MY00 MONITORING REPORT

Round Hill Branch Restoration Site
Buncombe County, North Carolina
French Broad River Basin - 06010105

MEMORANDUM

Date: May 16, 2022
To: Matthew Reid, DMS Project Manager
From: Adam Spiller, Project Manager
KCI Associates of North Carolina, PA
Subject: MY-00 Monitoring Report Comments
Round Hill Branch DMS #7534, Contract 100066
French Broad River Basin CU 06010105
Buncombe County, North Carolina

SITE PLAN

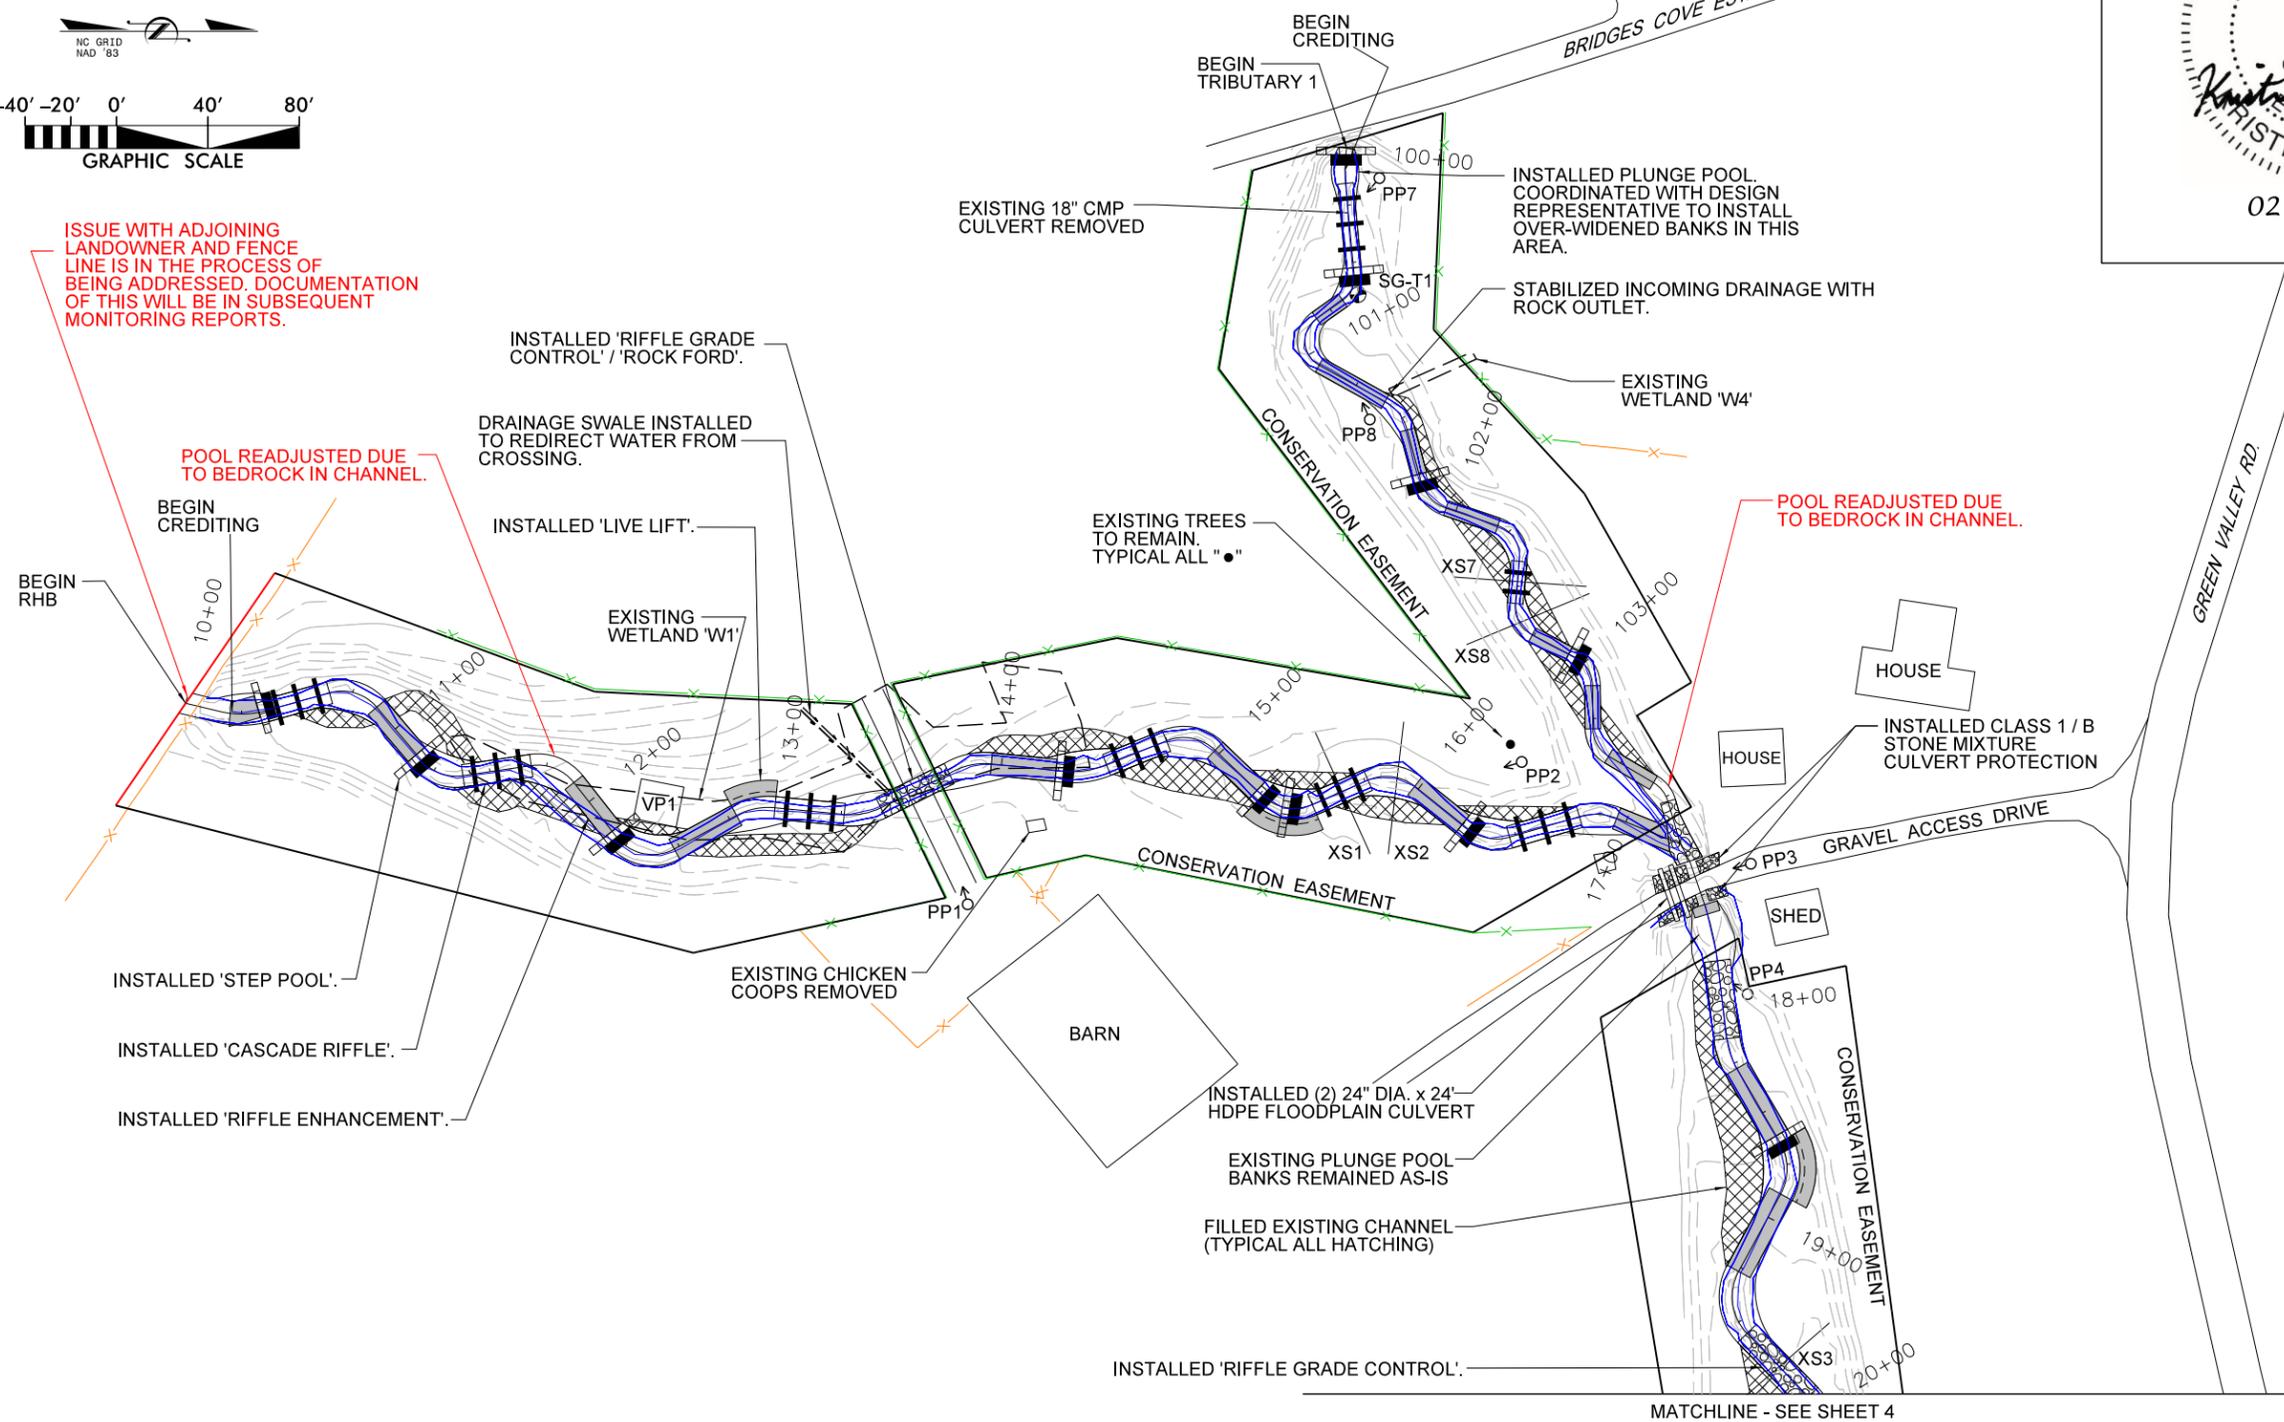
4. Photo point 5 and SG2 are shown in the incorrect position on the CCPV relative to the asbuilt. Please review and revise.
KCI Response: The locations shown on the CCPV are the correct ones. The as-built drawings will be corrected to match the actual locations of these features. This error has been corrected.

5. XS3, XS4, photo point 5 and SG2 all shifted upstream by one meander length. This appears to be the only deviation from the proposed monitoring plan in the approved mitigation plan. Please provide a brief explanation why the location was changed.
KCI Response: Photo point 5 was installed in the location shown on the proposed monitoring plan (the location shown on the as-builts was not correct and has been corrected). XS3 and 4 were moved upstream to avoid the large tree that was left intact in the location of the proposed cross-sections. SG2 (which has been relabeled as SG-RHB) was moved downstream from its proposed location to XS5 to better capture bankfull events that occur on site.

6. Please include the installed fence layer and existing fence layer on the CCPV and asbuilt/redline drawing. The installed fence should be a surveyed layer to verify correct placement.
KCI Response: The installed fence and existing fence layers have been added to the CCPV and the asbuilt/redline drawing.

9. The two areas of property/conservation easement dispute should be clearly marked in red on the asbuilt. Construction of riffle enhancement at the top of RHB did not extend to the CE boundary. Construction stopped at the existing fence line within the CE boundary.
KCI Response: These two areas have been addressed in the report and asbuilt plan sheets.

12. Two pattern deviations are shown on the asbuilt, but not called out as redline changes. RHB 12+00 and Tributary 1 104+00. Please update asbuilt and explain deviation.
KCI Response: These two small pattern deviations are due to bedrock in the channel that was discovered during construction. They have been called out as redline changes on the as-built drawings.

- A drainage swale has been constructed on the left floodplain on the upstream side of the crossing near sta: 13+50 on RHB to alleviate land owner concerns for water that was directed into the crossing. This feature was not depicted on the asbuilt or CCPV. Please include this feature on the asbuilt, CCPV and include a feature shape file in the digital deliverable. Please verify the property owner understand this swale cannot be maintained as it is inside the conservation easement. DMS recommends mulch, seed and matting for this feature.
KCI Response: This feature has been added to the as-built drawings and the landowner has been informed that this swale may not be maintained.

ISSUE WITH ADJOINING LANDOWNER AND FENCE LINE IS IN THE PROCESS OF BEING ADDRESSED. DOCUMENTATION OF THIS WILL BE IN SUBSEQUENT MONITORING REPORTS.

POOL READJUSTED DUE TO BEDROCK IN CHANNEL.

POOL READJUSTED DUE TO BEDROCK IN CHANNEL.
